**SUBJECT: ARKANSAS NUCLEAR ONE – NRC INSPECTION REPORT 05000368/2016011
AND PRELIMINARY WHITE FINDING**

IR 05000368/2016011; 09/16/2016 – 12/21/2016; Arkansas Nuclear One, Unit 2; Inspection Report; Follow-up of Events and Notices of Enforcement Discretion.

.1 Unit 2 Emergency Diesel Generator A Bearing Failure

AREA: B	ELEV: 368'-0"	ZONE: 2200-MM		
ARKANSAS NUCLEAR ONE UNIT 2 RUSSELLVILLE, ARKANSAS			SCALE : NONE	
			DRAWN : C. DUNAWAY	
FIRE ZONE DETAIL TURBINE BUILDING CONDENSER AREA		DESIGN : ENTERGY		
		CAD NO : 00020186.f2r		
		DETAIL NO.	SHEET	REV
		FZ-2037	1	2

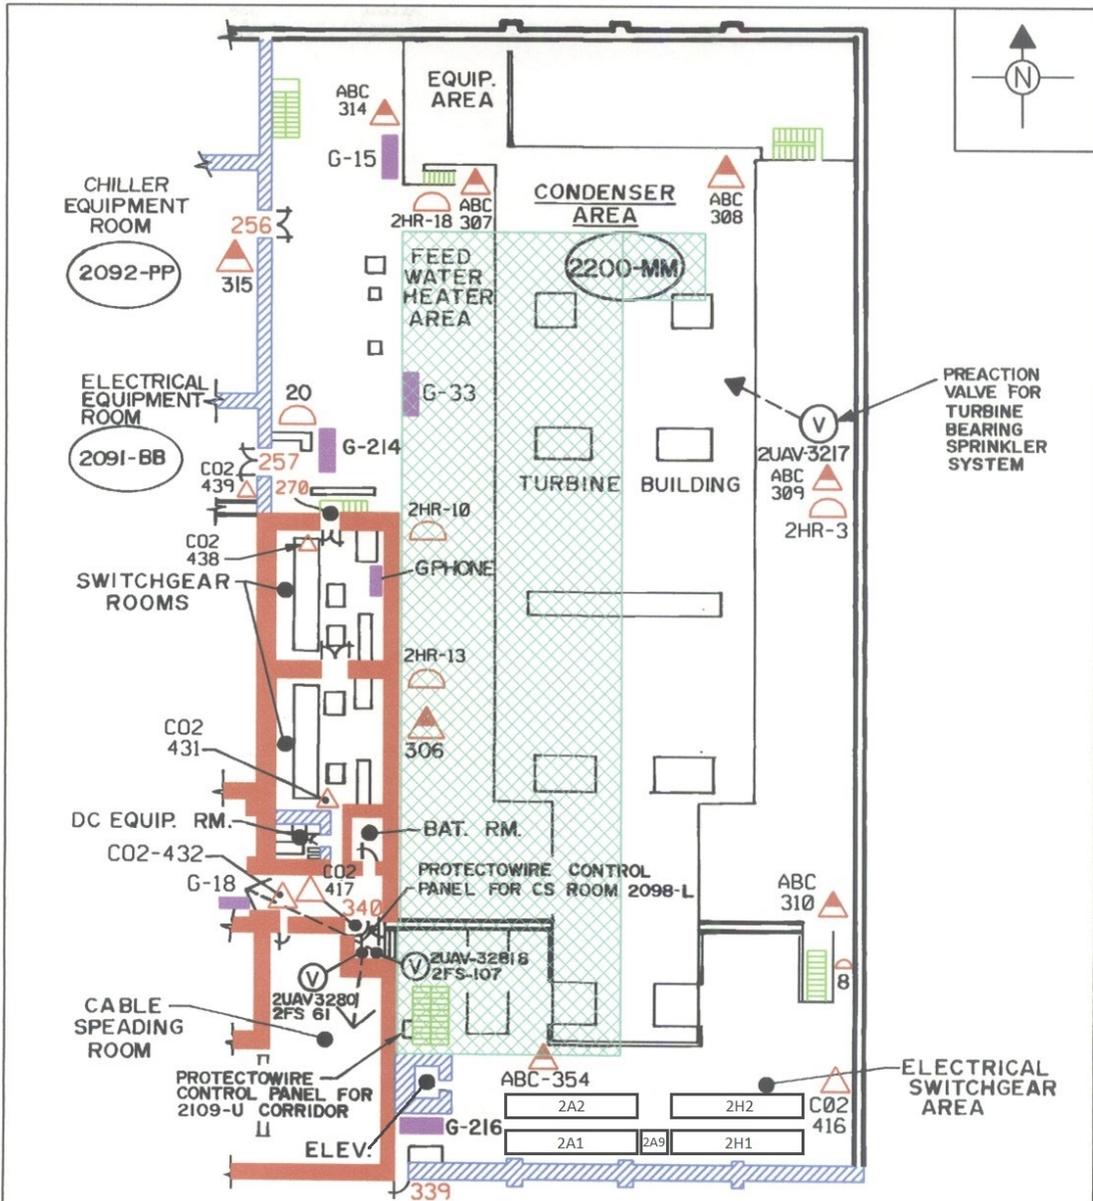
A fire that impacted more than one of the three buses of concern had a significant impact on the results. Therefore, the analyst evaluated the fire spread probabilities. The severity factors were assumed to be 1.0 for the licensee's NFPA 805 analyses for the fire scenarios of interest. The analyst then adjusted the severity factors to model more realistic fire scenarios and to remove some of the conservatism inherent in the NRC and industry approved methodologies. These methodologies included treatment that a fire started in one electrical switchgear would always spread and render the other redundant electrical switchgear unavailable (e.g., a fire in switchgear 2A-1 would always render switchgears 2A-2 and 2A-9 unavailable). This simplification was made during the NFPA 805 licensing process because of the close proximity of the cabinets and the low importance of such a fire scenario with all other equipment fully functional.

As shown in the following figure (taken from the ANO Unit 2 pre-fire plans and enhanced for emphasis), the simplified modelling assumed a fire in switchgear 2A1 would always affect switchgear 2A2 because of their close proximity to each other (6 feet apart). Likewise a fire in switchgear 2A2 would always affect switchgear 2A1. The same spatial relationship and fire

spread assumptions applied to switchgears 2H1 and 2H2. Switchgear 2A9 is situated between switchgears 2A1 and 2H1 and is 6 inches from each switchgear.
